Access Compliance Report

Public Rights-of-Way

| Intersection ID: 13754 | Main Street: S_MCDOWELL_ST | Cross Street: BAXTER_ST | Location: S |
| ADA ID: 3EE892DB29BF | Ramp Type: Combination1 | Initial Pass/Fail: Fail | Overall Compliance: No |

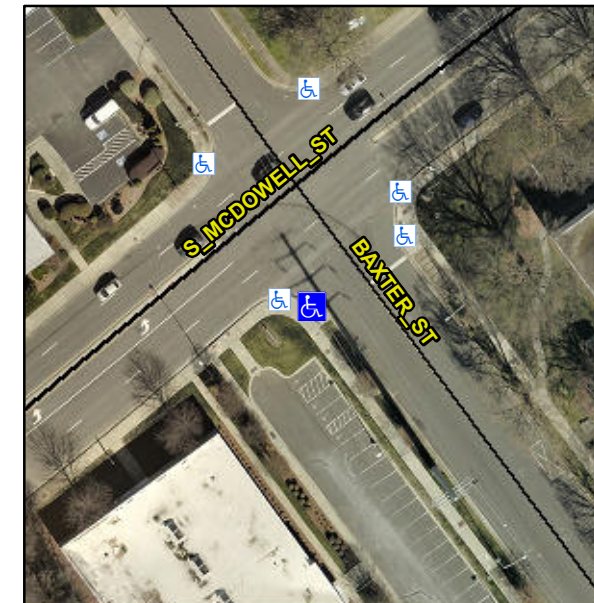
Not Found, R304.5.1, R304.3.2

| Compliance | Description | Data | Compliance | Description | Data |
|------------|-----------------------|-------|------------|-----------------------------|------|
| Yes | Ramp Slope LT (%) | 6.2 | No | Ramp Slope RT (%) | 10.6 |
| No | Ramp Width (in) | 47.0 | Yes | Ramp XSlope (%) | 1.3 |

Remove & Replace Entire Ramp.
